Division of
Oil, Gas & Mining

SUBJECT: Site Inspection, American Gilsonite, Bonanza Operations,
M/047/010, Uintah County, Utah

Photo 1. R-2.

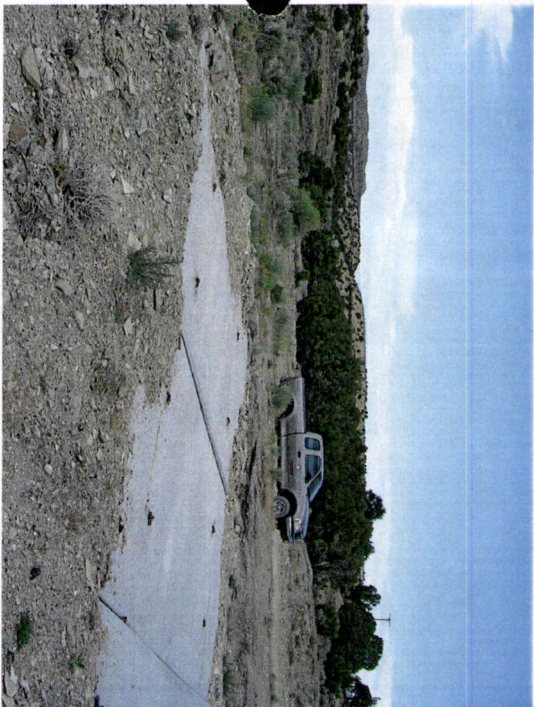
Site	Comments
R-2	Slabs placed over concrete footings (Photo 1). Natural invasion of rabbitbrush and snakeweed. Gap between two of the slabs (Photo 18), and some evidence of piping or rodent burrows (Photo 19).
R-4	Polyurethane foam used to seal the openings. No evidence of failure. Almost no signs of surface disturbance (Photo 3). A lot of cheatgrass in some areas (Photo 4), but there is natural invasion of native species (Photos 2 and 3).
H-2	Natural invasion of snakeweed and rabbitbrush but still a lot of halogeton. Surface is rocky. Shaft sealed with polyurethane foam. No evidence of failure. Photos 5 and 6.
H-10	Openings sealed with polyurethane foam with no evidence of failure. Vegetation on the access road is coming along nicely with a fair amount also

Site R-2 could be released but for a few minor problems. The gap between the concrete slabs should be filled, and the operator should fill the hole shown in Photo 19 and pile dirt so water would drain away from the cap. In addition, the Division has some concerns about the slabs, but these concerns should not stop release. Chains were incorporated with the concrete for lifting the slabs, and as these chains rust, the concrete may deteriorate. I have not seen documentation that reinforcing steel was used in these slabs, but, assuming it was, it was probably not coated. For these reasons, even when the site is released, it should be periodically inspected.

Photo 20. Another view of B-28.

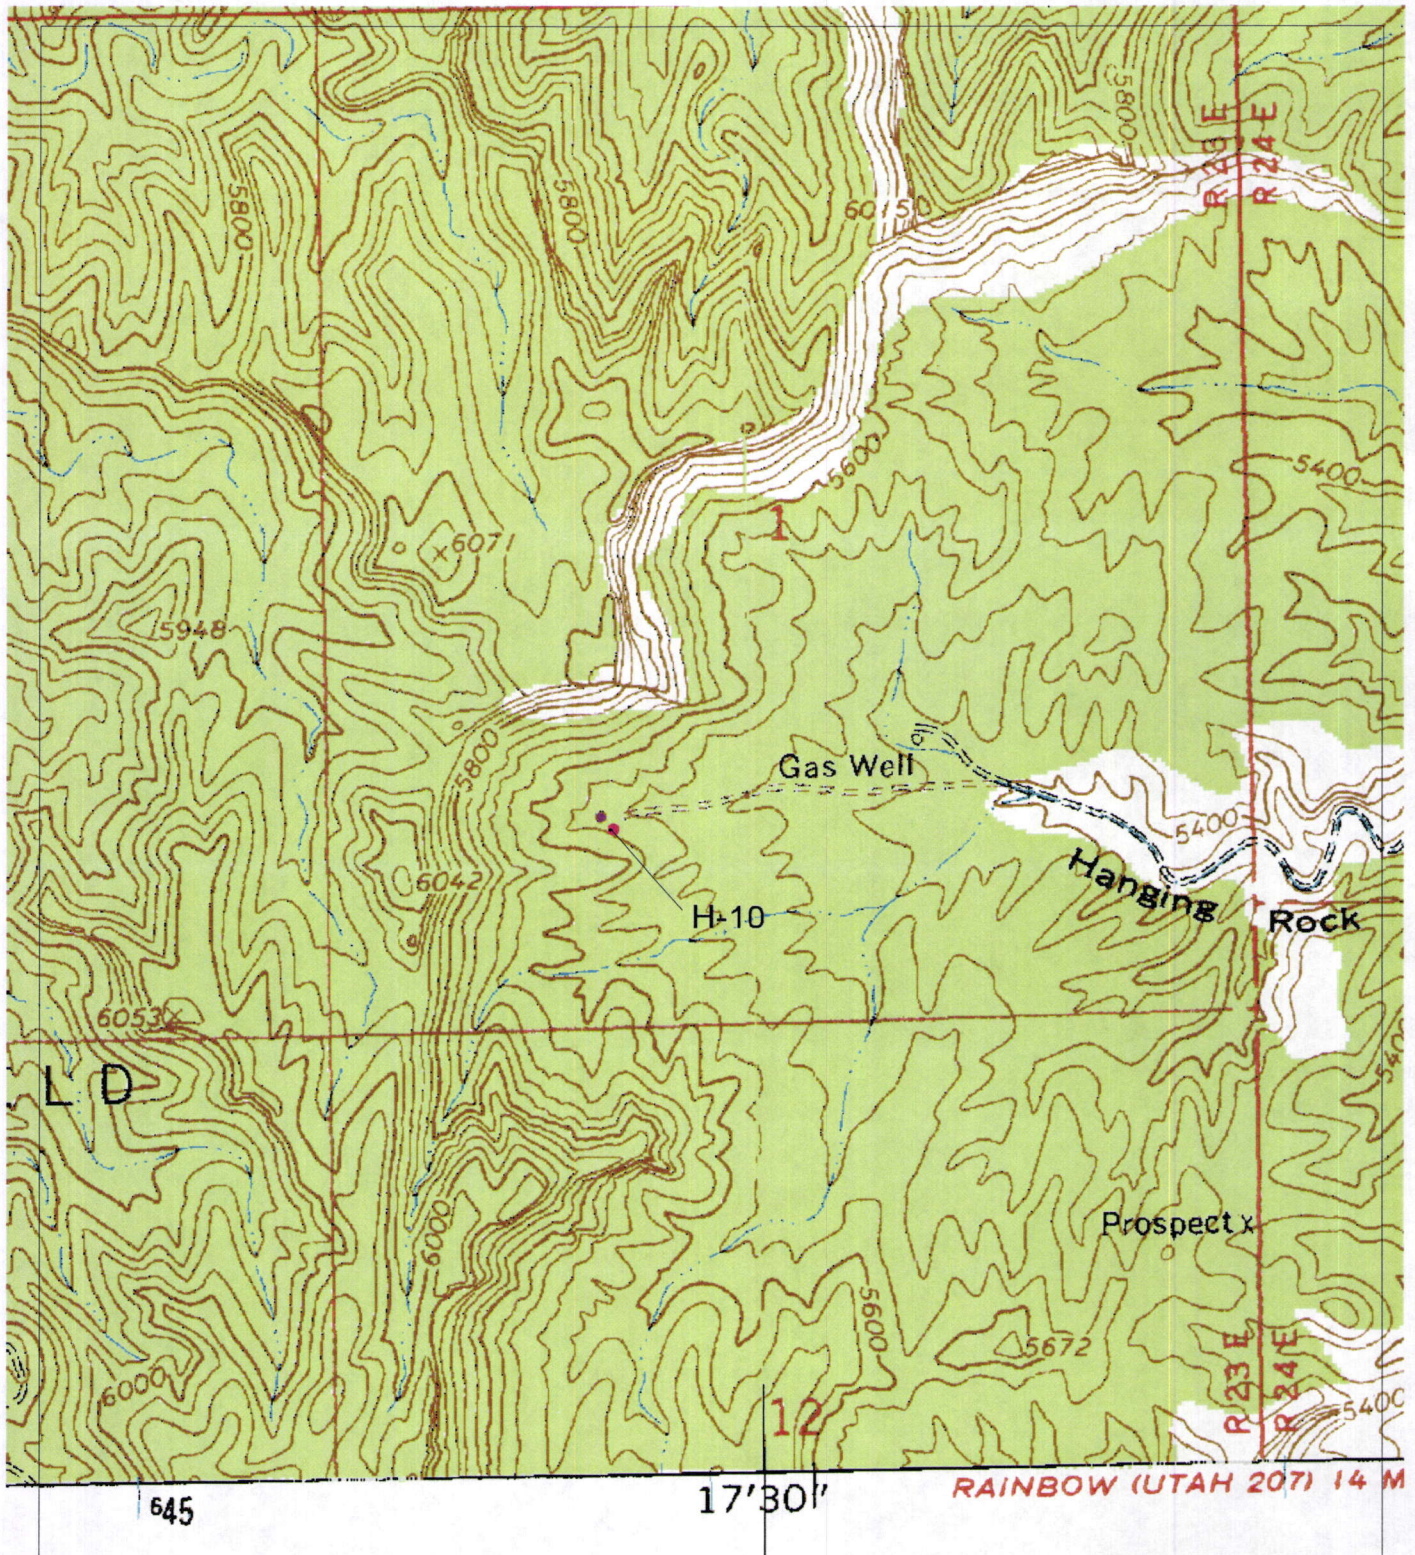
I-30	The equipment is gone, but the operator may come back again (Photo 16).
I-16	This site needs to be capped and the area seeded. The equipment has been removed. Did not take a picture.
B-28	Photos 17 and 20. Equipment is gone, and the site is being reclaimed. This area was re-impacted by mining.

Looking at the pictures of B-28 (Photos 17 and 20), it is not clear whether this site has been excavated to bedrock. Before pouring concrete, the operator should be sure the footing goes on bedrock.
